HOPE CREEK GENERATING STATION  
DOCKET NO. 50-354  
FSAR COMMITMENT STATUS THROUGH AUGUST 1984

ATTACHMENT I  
HOPE CREEK GENERATING STATION  
FSAR COMMITMENT STATUS THROUGH AUGUST 1984

QUESTION 220.21 (SECTION 3.7.2)

FIGURE 220.21-46  
 RESPONSE SPECTRA COMPARISON,  
 INTAKE STRUCTURE AT ELEV. 93' -0".  
 F.W. CRE. 7% DAMPING

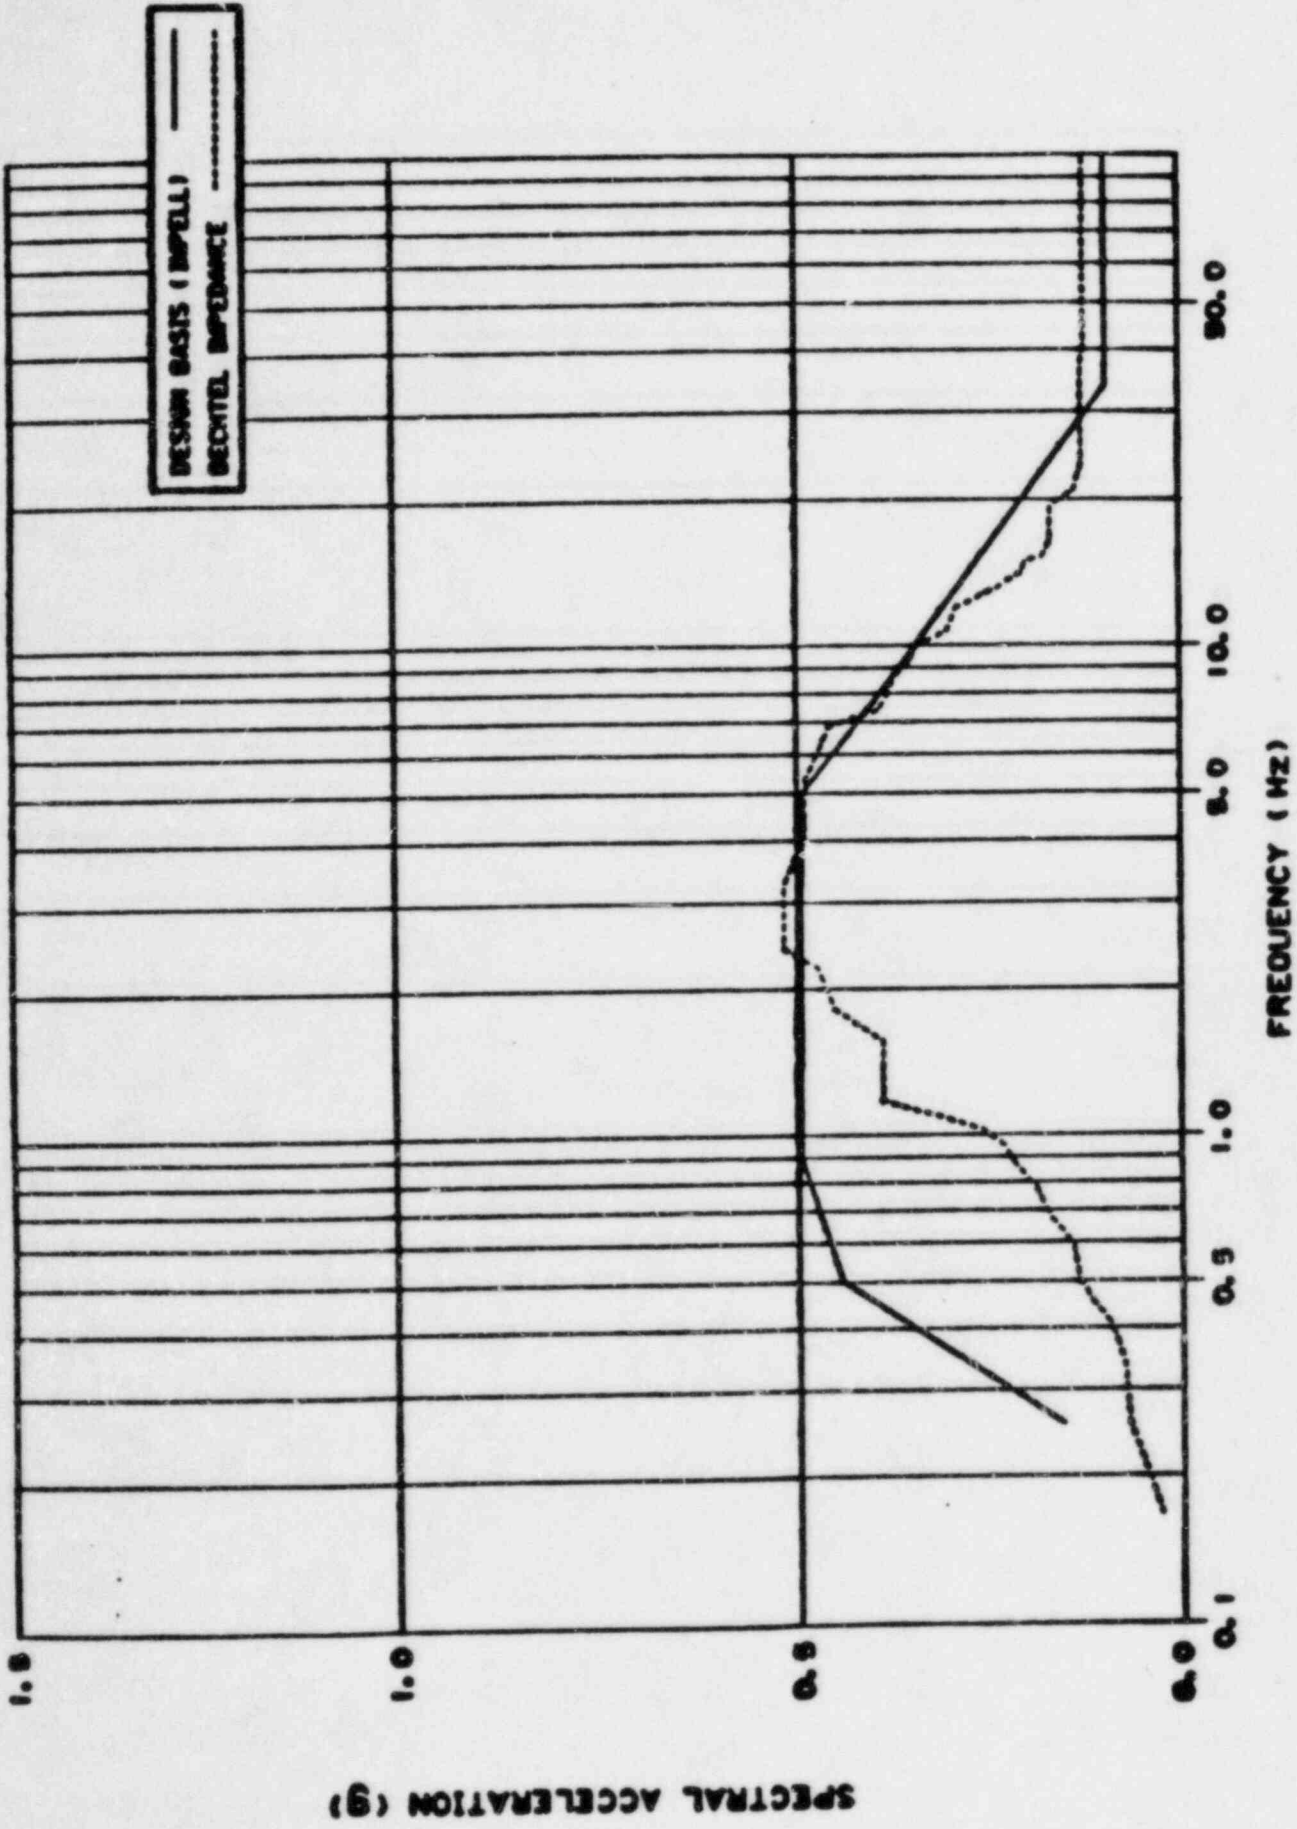
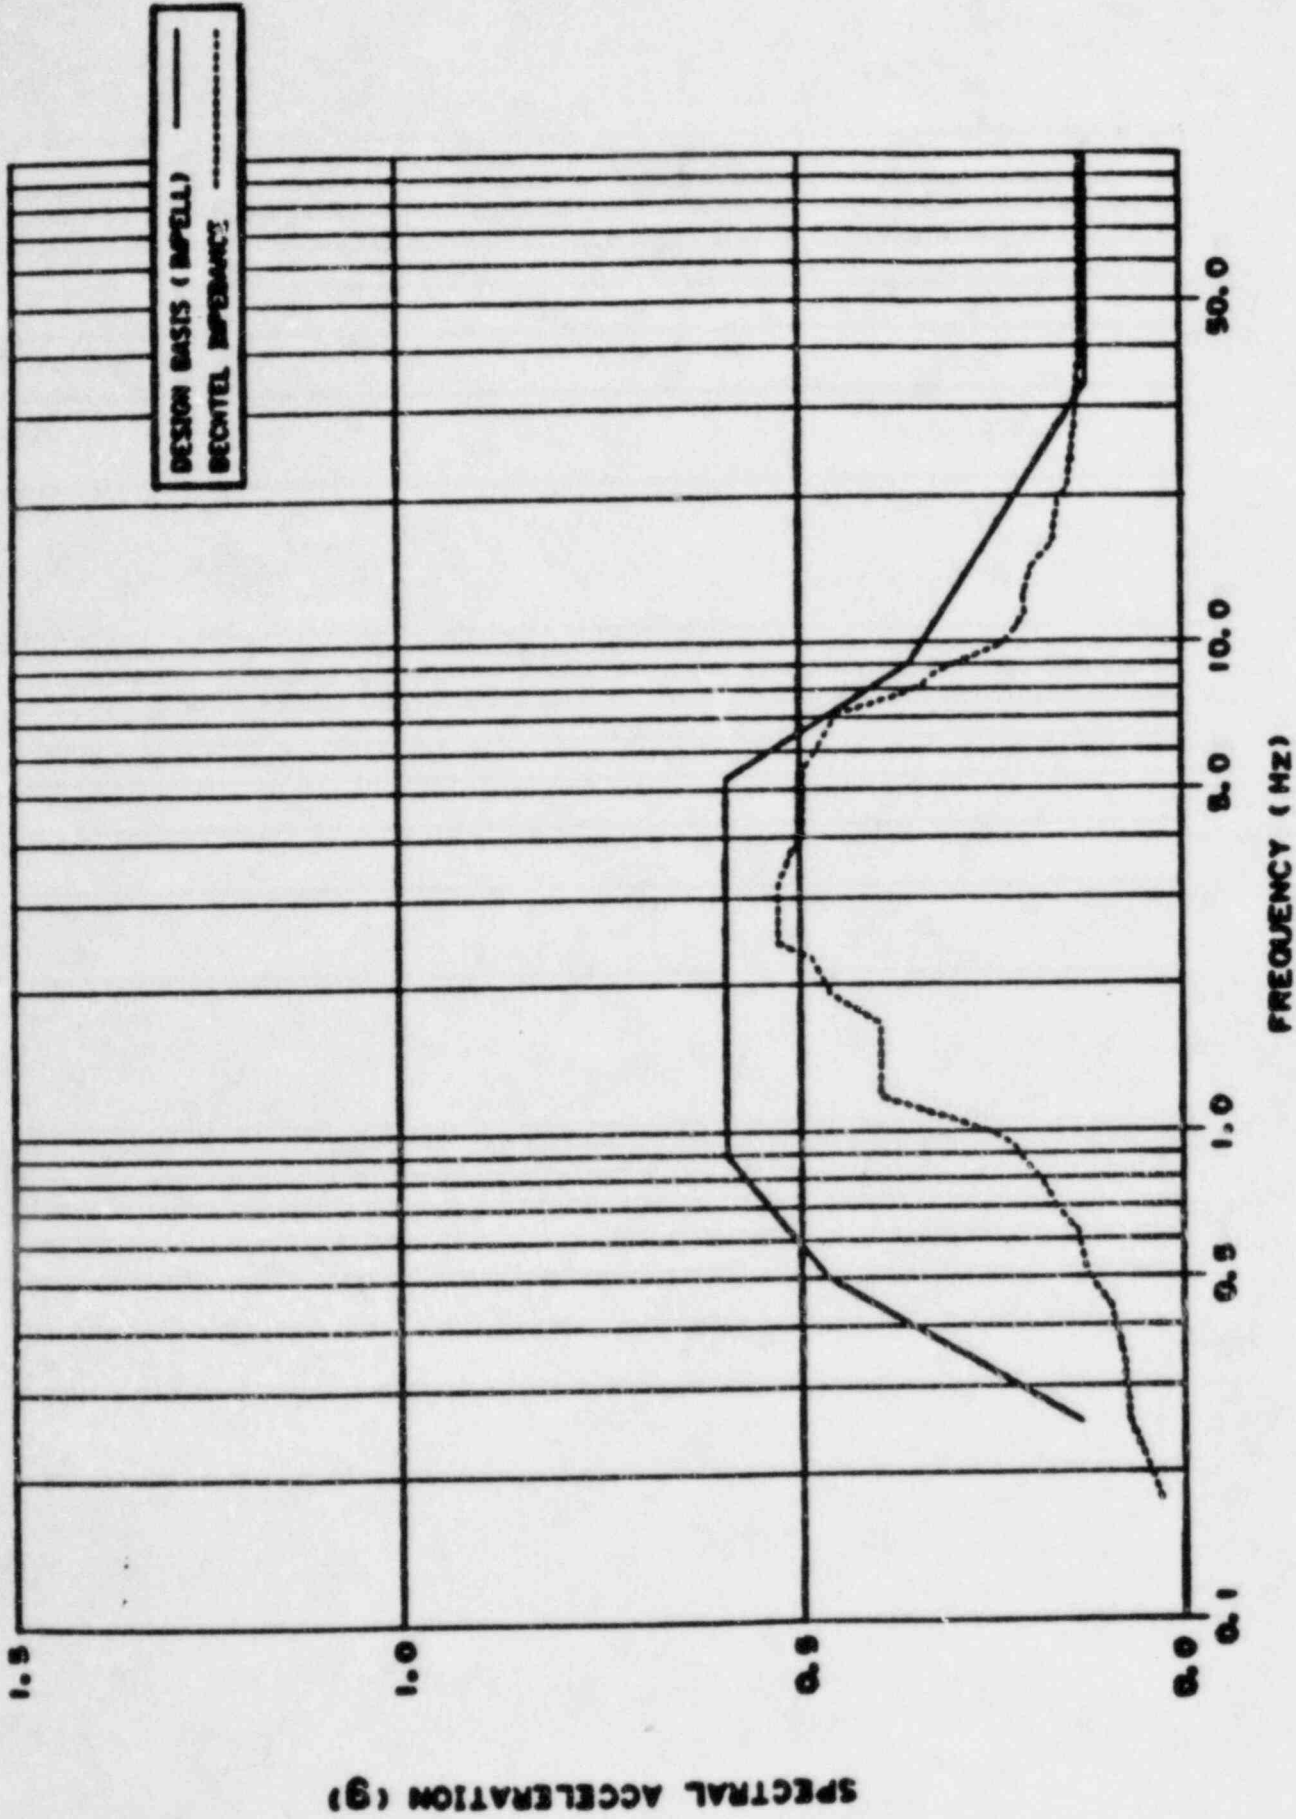
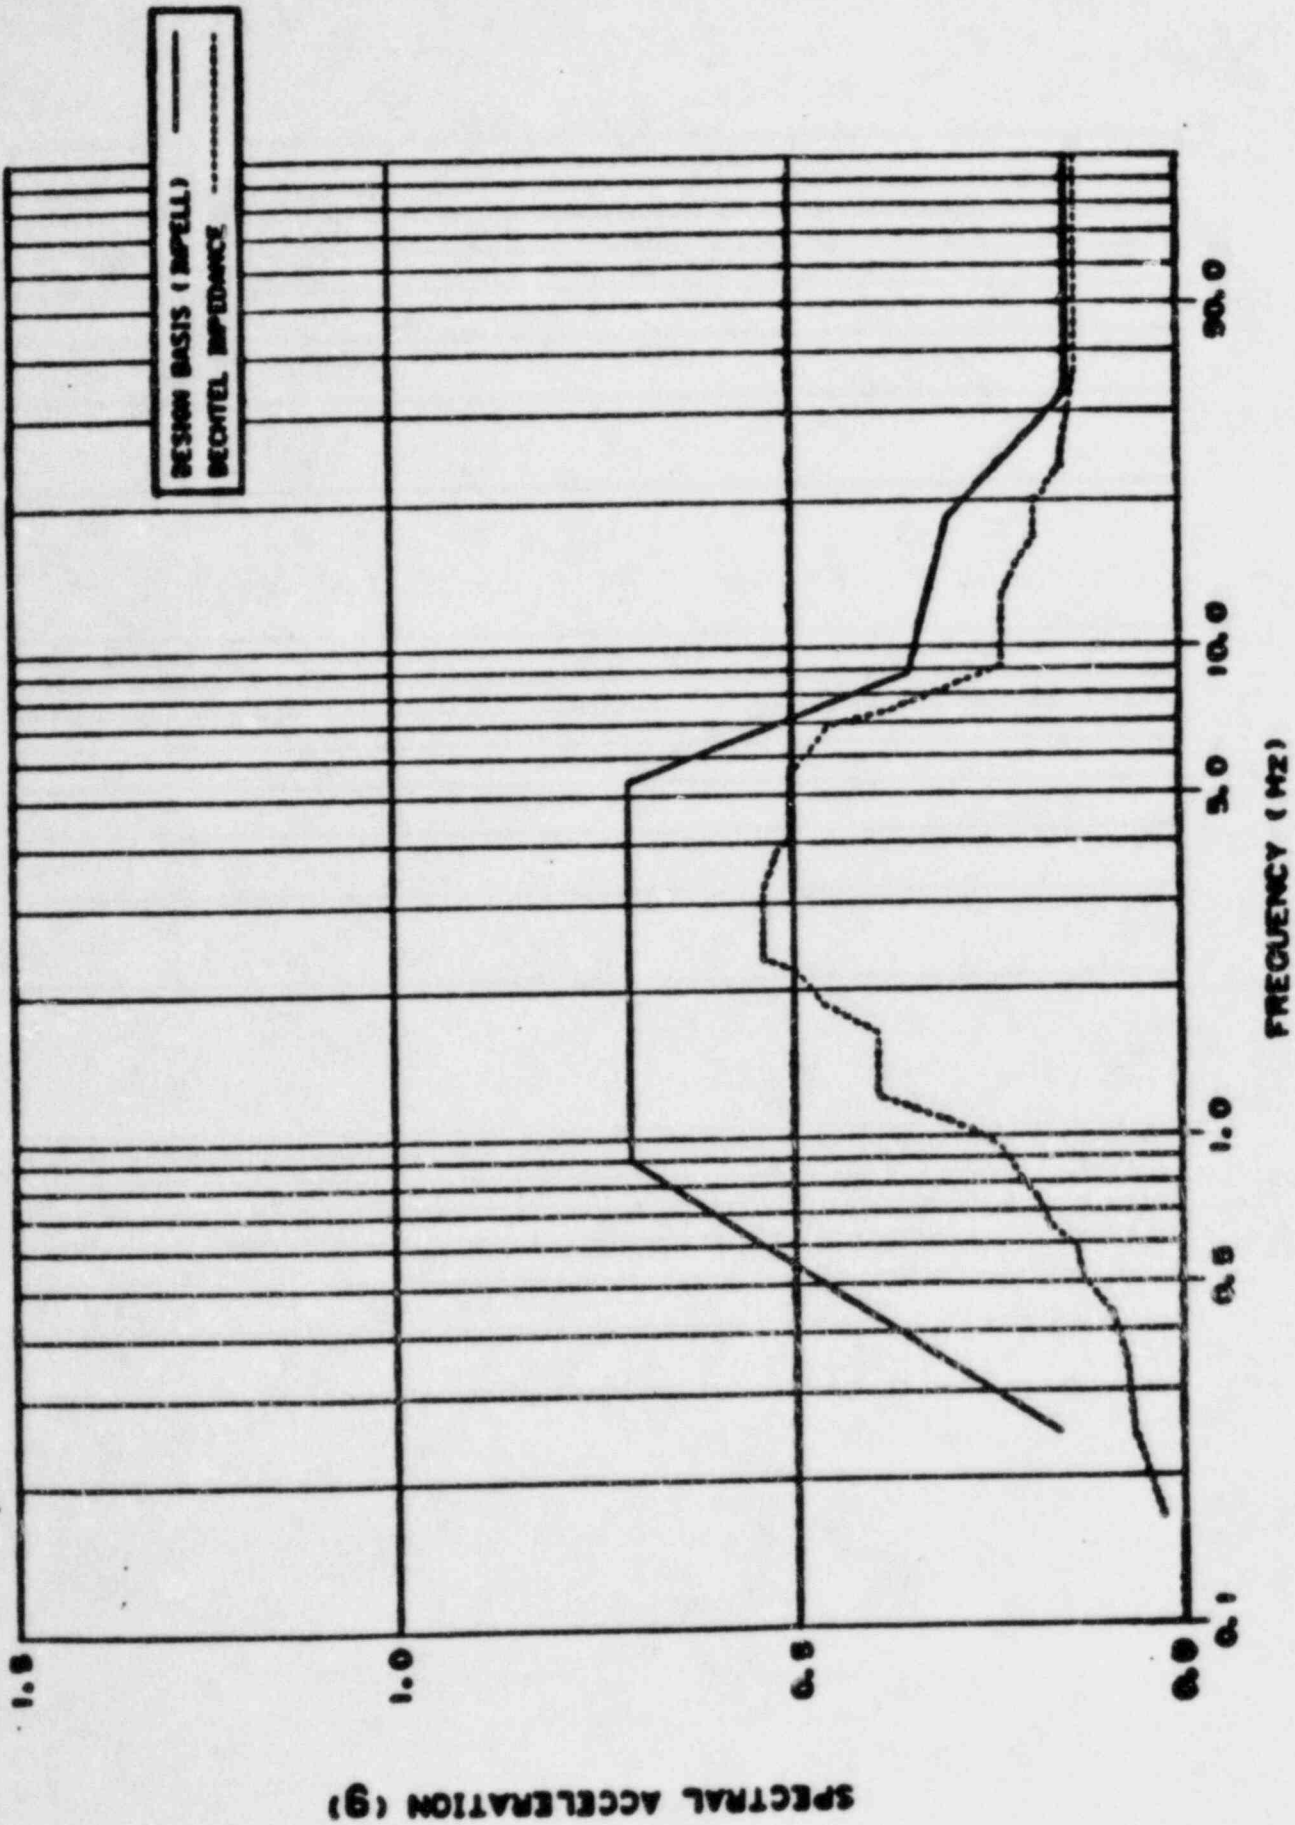
The Hope Creek soil-structure interaction analysis is performed by applying a specified earthquake input motion at the base of the finite-element model. The base level input motion is generated through a deconvolution analysis. The applicable SRP criteria for soil-structure interaction analysis require that both the half-space and finite-element approaches should be considered. (For details refer to SRP 3.7.2-11.4). Public Service should perform necessary analyses to demonstrate conformance to the criteria.

Figures 220.21-1 through 220.21-54 show a comparison of the 2 percent damping response spectra obtained from the design basis finite element and the impedance analyses for the reactor building, auxiliary building and the service water intake structure (SWIS).

¶ For the reactor and auxiliary buildings, the peak spectral accelerations obtained from the impedance analysis are generally lower than those obtained from the design basis analysis. However, the impedance analysis response spectra are not completely enveloped by those obtained from the design basis analysis, especially in the frequency range from 1.0 to 3.5 Hz. Also, there are some local exceedances in the higher frequency range, as shown in Figures 220.21-1 through 220.21-36. ¶ For the SWIS (Figures 220.21-37 through 220.21-54), the impedance analysis response spectra are generally enveloped by those obtained from the design basis analysis at elevation 114.0 feet. For other elevations, the impedance analysis spectral accelerations exceed the design basis spectral accelerations in some frequency ranges. These ranges vary approximately between 1.5 and 10.0 Hz.

forces and moments obtained from the impedance analysis exceeded the design basis values at various locations within these buildings. The auxiliary building seismic shear forces and moments obtained from the impedance analysis are less than the design basis shears and moments.

Since the impedance analysis results are not completely enveloped by the design basis finite element analysis results, sampling studies are conducted to confirm the adequacy of the plant design. These sampling studies include an evaluation of the following items:

In all cases, the items reviewed during these sampling studies can accommodate the loads resulting from the impedance analysis. Therefore, the impedance analysis results have no impact on the plant design.
